**Staff Report to the Board of Architectural Review**

Design Review for Greenwood Heating

**File Number:** L20-0011 Design Review

**Applicant:** Greenwood Heating

**Fig. 6: Landscaping Plan**

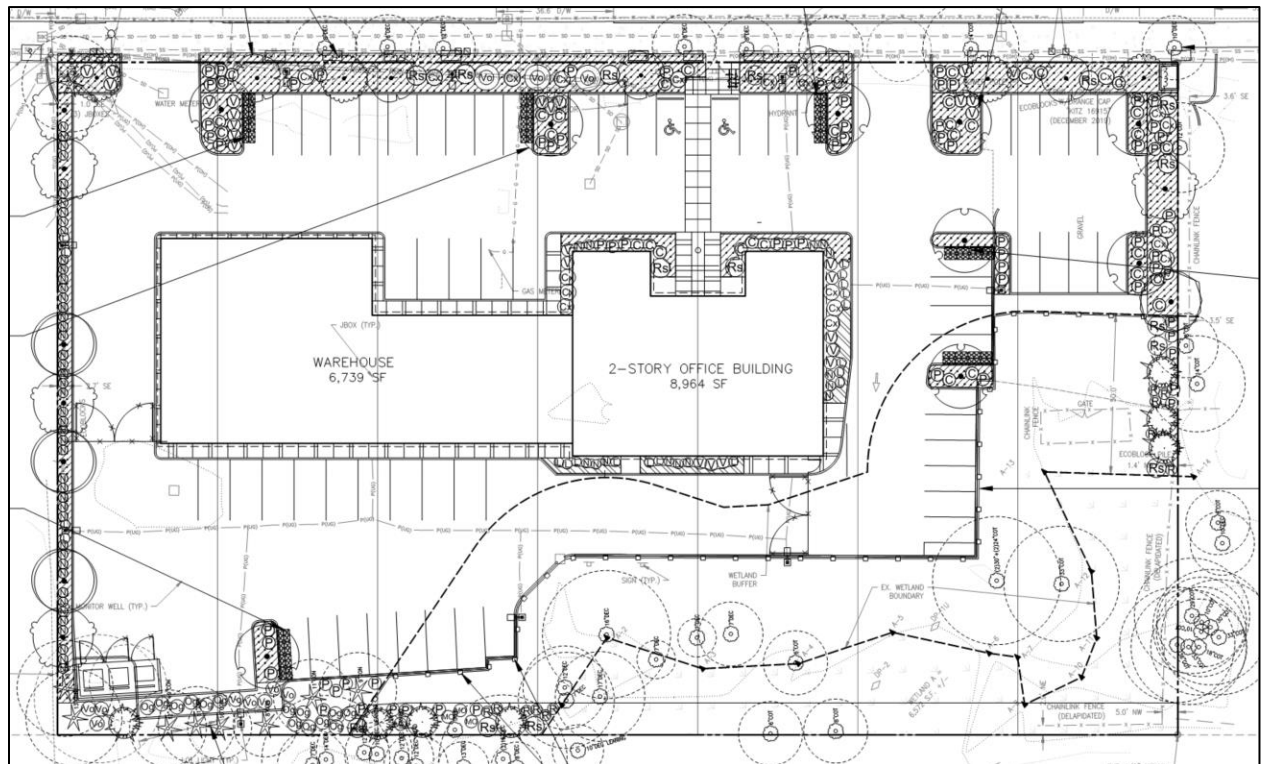
The proposed project's site design and landscaping effectively conceals large paved areas. A large portion of the parking is located on the western portion of the site and screened by the proposed building, see Fig. 6. Parking areas to the south and east include perimeter and interior landscaping as required by TMC 18.52, breaking up the appearance of large paved areas in these locations. Landscaping along the eastern property line between Interurban Ave S and the parking lot will also provide sufficient screening from the streetscape while still providing views into the site.

**Fig. 7: 10' native landscaping area colored in orange.**

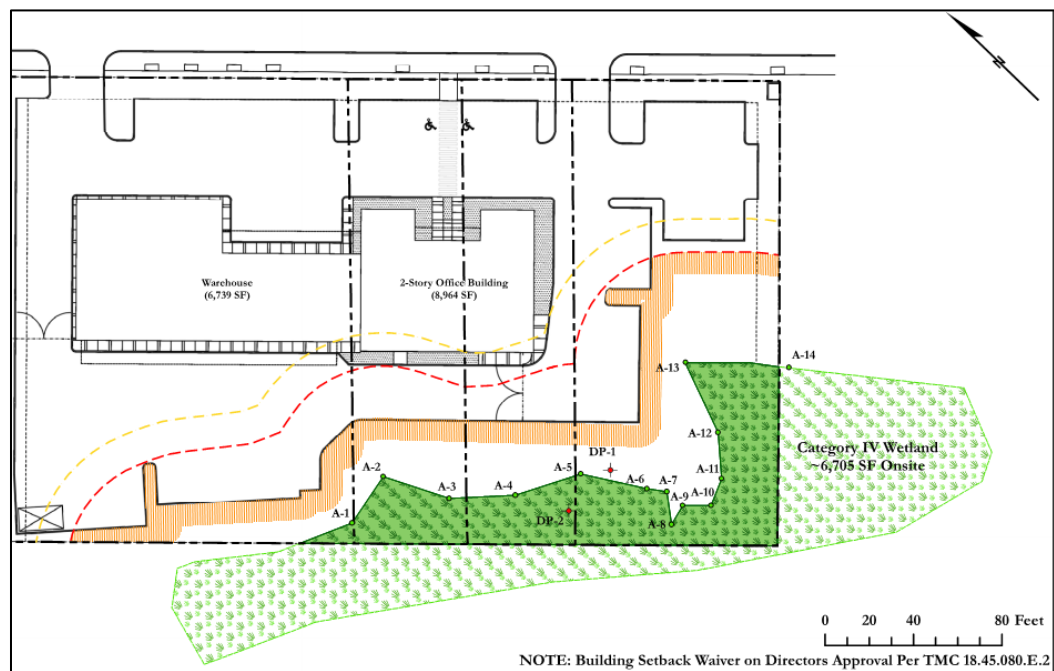
The proposed project provides Type II perimeter landscaping along the southeastern side yard (10' due to proximity to LDR zoning) and northwestern side yard (5') consisting of small trees and shrubs, providing an appropriate transition between the property and adjacent properties. The southwestern boundary line provides 10' of landscaping at the parking area's edge within the wetland buffer that consists of native plants (Sitka spruce trees and native grasses).

**Fig. 8: Traffic layout (service parking area shaded in blue)**

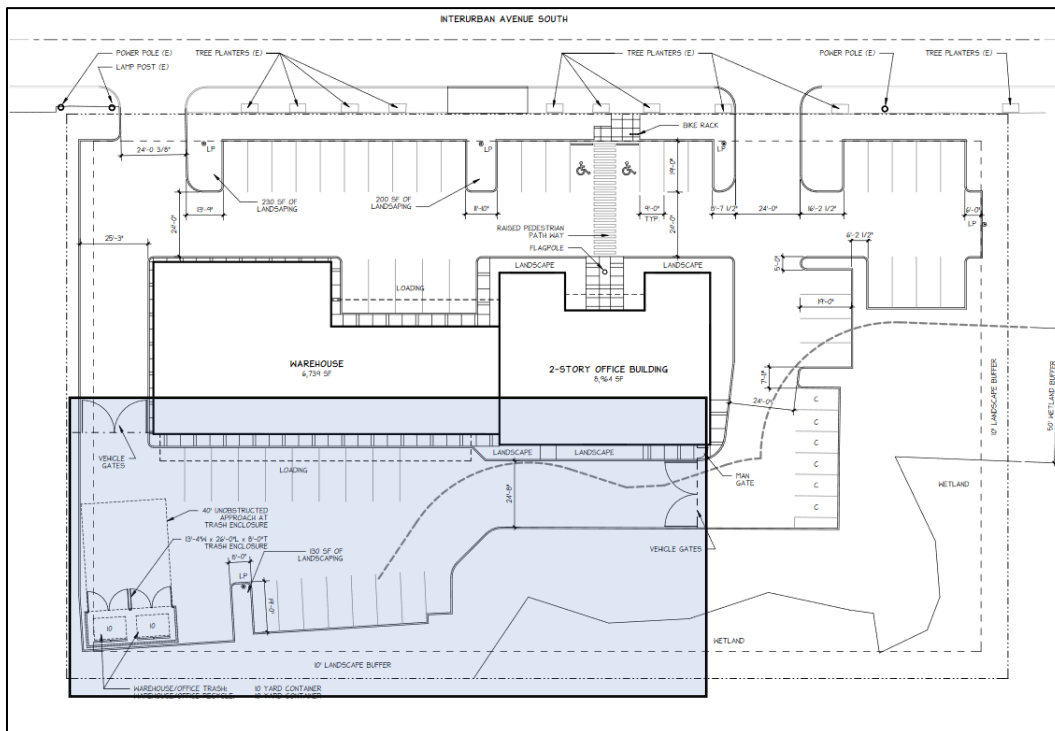
- **Compatibility of on-site vehicular circulation with street circulation should be encouraged:**  
The existing three curb cuts along Interurban Ave S have been consolidated into two, effectively reducing the potential for traffic conflicts for cars entering and exiting the site. Service trucks will mainly be directed to the rear of the building (blue area, Fig. 8) while the front of the building will be reserved for office traffic and parking.

**Fig. 11: Building elevation, main entrance.**

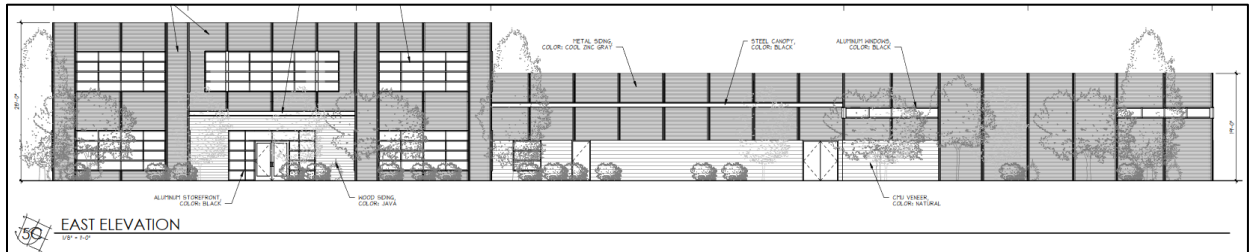
The windows of the office portion of the building are located to provide symmetry. The second and third floor windows are of the same size and located directly above/below one another except for the second story window above the main entrance; this window will be slightly wider than the others and aligned directly above the main entrance, accentuating the significance of the entrance itself.

The warehouse section will utilize narrower horizontal windows to provide natural lighting into the space while reducing exterior views into this more industrial portion of the structure. Awnings along this section will also emphasize the horizontal design of this portion of the building while providing weather protection on the ground for users loading materials into vehicles from warehouse.

**Fig. 13: HVAC location.**

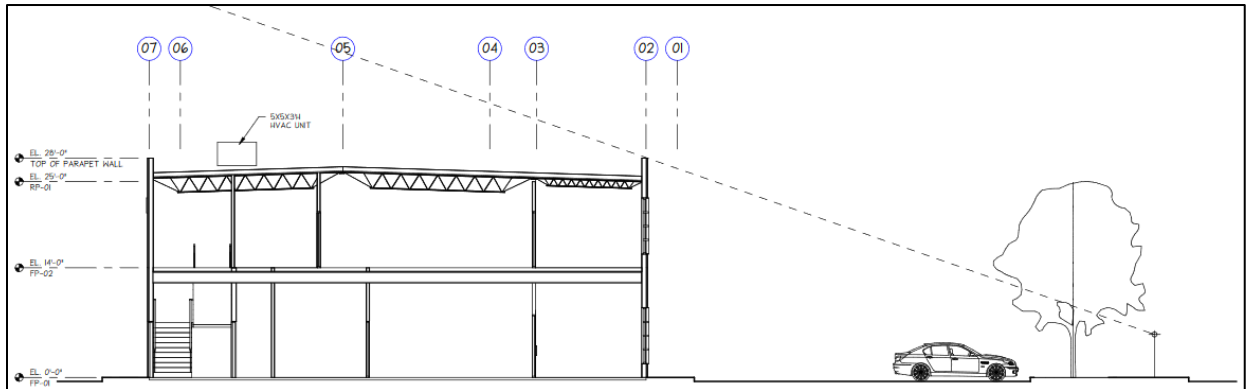
Rooftop mechanical equipment will be placed toward back of building and screened with parapets to reduce visibility from Interurban Ave S, see Fig. 13.

**Fig. 14: Building Modulation.**

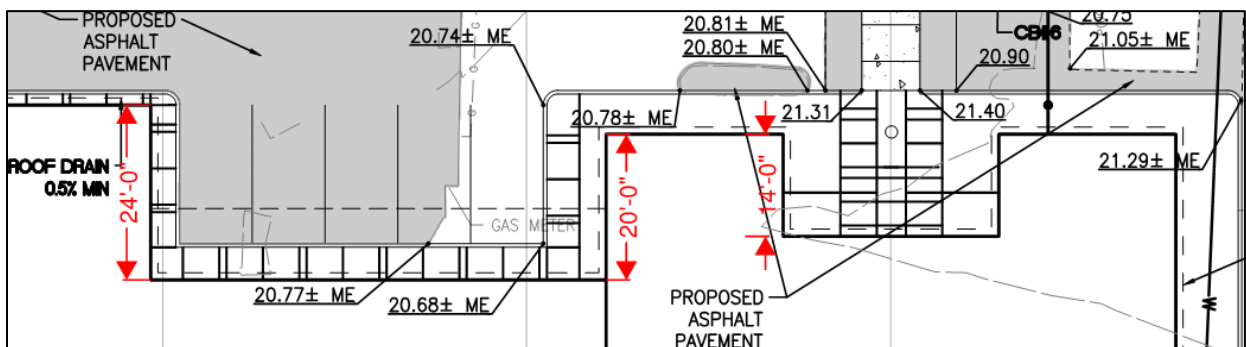
The proposed structure provides visual interest in multiple ways. Vertical modulation has been incorporated by setting the main entrance 14' back and half of the warehouse façade 20-24' back from the rest of the building, see Fig. 14. Materials are varied along the building façade, with zinc gray metal siding used as the primary siding material, java wood siding used as an accent around the main entrance, CMU natural veneer used along extent of parking area adjacent to the warehouse, and black steel and aluminum used for awnings and window trims.
